Economic Commission for Europe**Inland Transport Committee****World Forum for Harmonization of Vehicle Regulations****Working Party on Lighting and Light-Signalling****Eighty-fifth session**

Regulations Nos. 37 (Filament light sources), 99 (Gas discharge light sources), 128 (Light emitting diodes light sources) and the Consolidated Resolution on the common specification of light source categories**Proposal for an amendment to the original version of the Consolidated Resolution on the common specification of light source categories****Submitted by the expert from the International Automotive Lighting and Light-Signalling Expert Group (GTB)***

The text reproduced below was prepared by the expert from the International Automotive Lighting and Light-Signalling Expert Group (GTB) with the aim to amend the Consolidated Resolution on the common specification of light source categories (R.E.5) (ECE/TRANS/WP.29/1127). There are no associated amendments to UN Regulations Nos. 37, 99 or 128. The modifications to the existing text of the Resolution are marked in bold for new or strikethrough for deleted characters.

Figure 1*

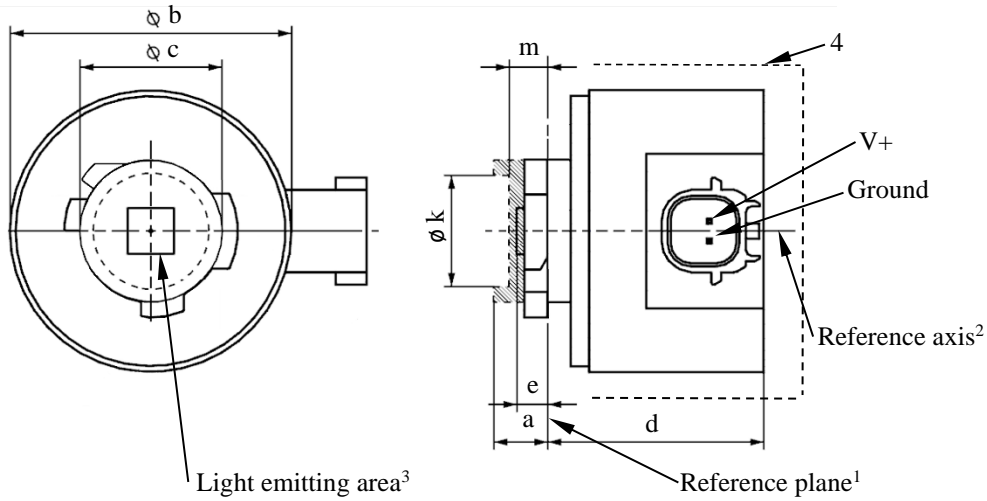
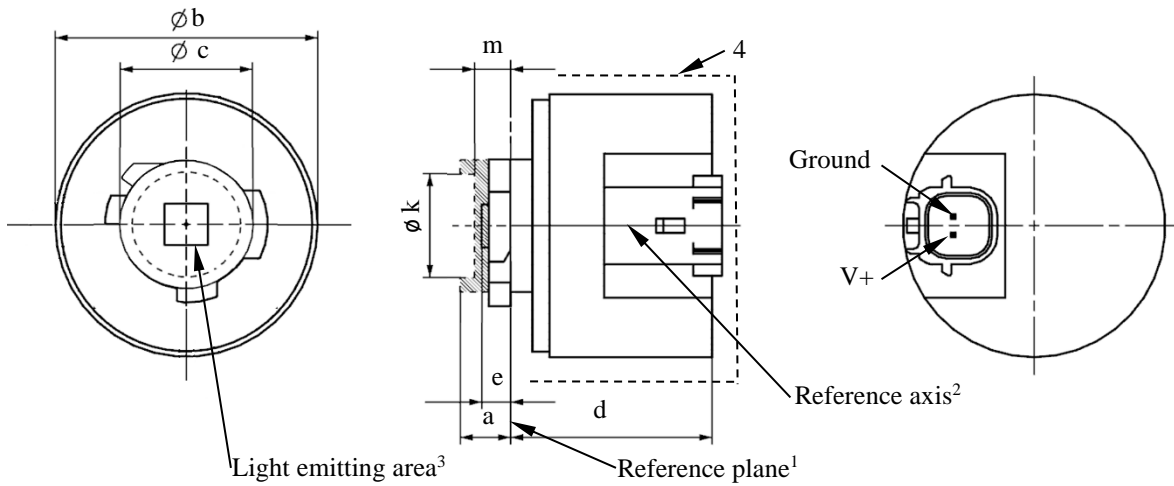
After sheet Lx5/6, insert new sheets Lx6/1 to 6, to read
(see following pages; one page per sheet):

2. Amendment with the aim to introduce new LED light source categories LR6A and LR6B

2.1. This proposal introduces new light-emitting diode (LED) light source categories for signalling to accommodate an increasing market demand for LED light sources according to UN Regulation No. 128. The ongoing trend towards style-driven rear lamps requires light sources with higher luminous flux to compensate for the lower efficiency of the corresponding optical designs.

2.2. In general, standardized and replaceable UN Regulation No. 128 LED light sources can serve individual rear lamp designs with limited development efforts. The proposed categories of a high luminous flux mono-function red light source are based on an established cap concept combined with an increased and more precise light output, while a new and future-proof specification of the light emitting area (LEA) allows a more reliable description of where the light originates from.

2.3. The cap/holder system for the new red emitting light source is based on the International Electrotechnical Commission (IEC) Inter PGJ18.5d fit, a family of cap/holders that has already been successfully employed in existing LED light sources in UN Regulation No. 128. Keys from the PGJ18.5d fit that are not in use so far have been assigned to the newly proposed categories. Following established LED light source categories, the new red emitting light source is proposed with an elbow connector at the side – the A version – as well as with a straight connector at the bottom – the B version. The assigned category designations are LR6A and LR6B respectively.

Figure 2

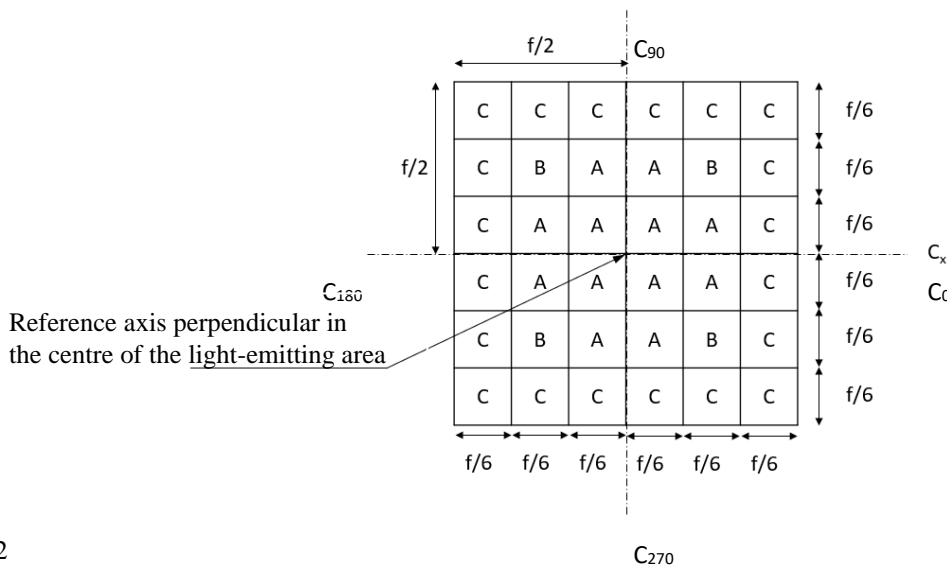
The position of the light emitting area is checked by the box system defined in Figure 2, which is aligned to the planes C₉₀ and C₁₈₀ and shows the projection when viewing along direction $\gamma = 0^\circ$ at $e = 3.0$ mm (C, γ as defined in Figure 3). The luminous flux Φ emitted into the viewing direction shall be calculated as given below:

The distribution of luminous flux originating from the LEA as shown in Figure 2 shall fulfil the requirements given in Table 3. All numbers shall be given in % of the total luminous flux emitted into the viewing direction from the bayonet core area, i.e. a circular area with diameter $c = 18.5$ mm (see Figure 1).

Figure 3

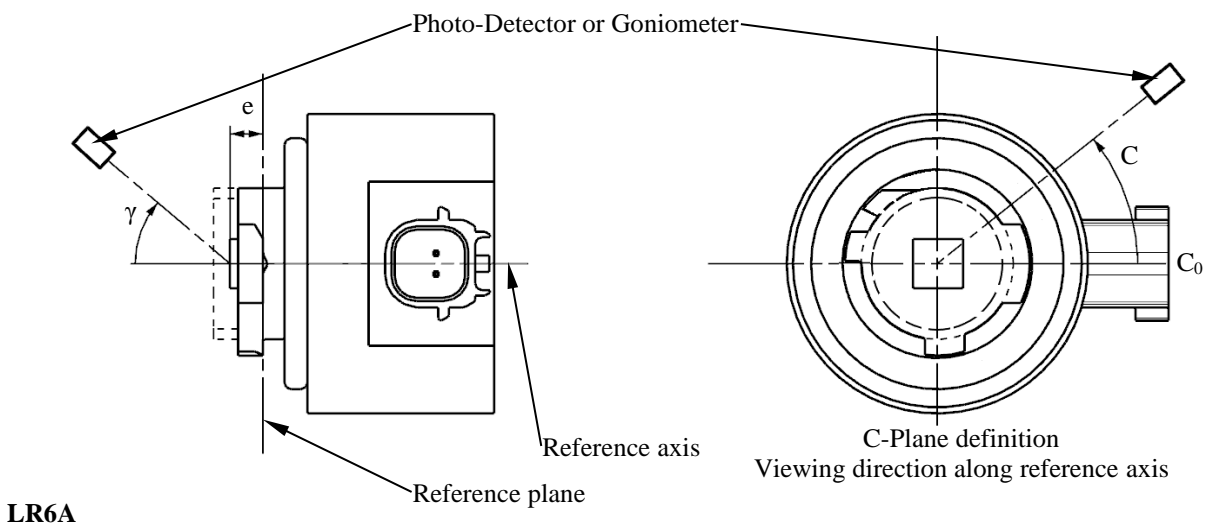
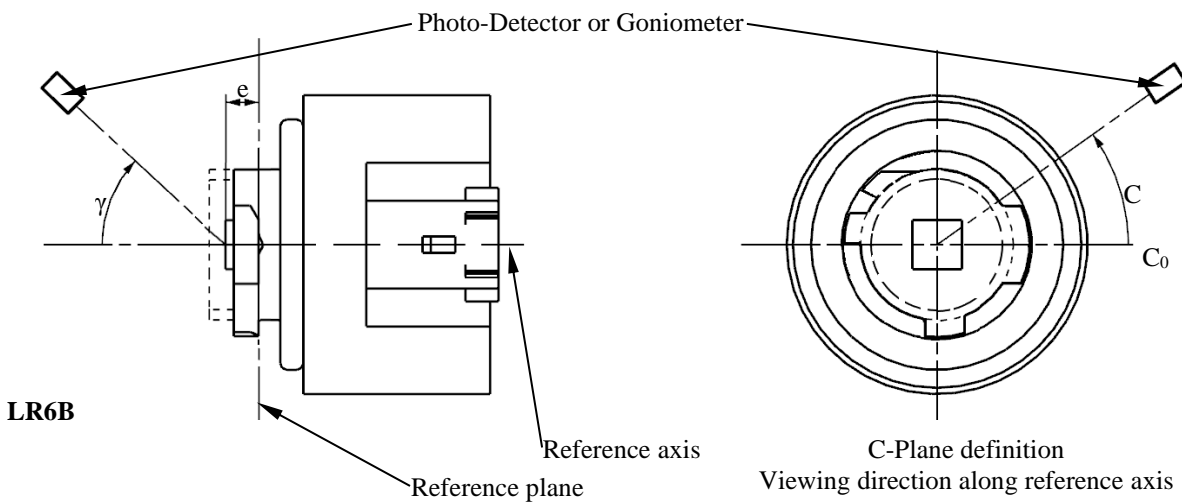
The following test is intended to determine the normalized luminous intensity distribution of the light source in an arbitrary plane containing the reference axis. The intersection of the reference axis and the parallel plane to the reference plane in distance $e = 3.0 \text{ mm}$ is used as the coordinate system origin.

The light source is mounted on a flat plate with the corresponding mounting lug features. The plate is mounted to the goniometer table by a bracket, so that the reference axis of the light source lines up with one of the rotating axes of the goniometer. The corresponding measurement set-up is described in Figure 3.
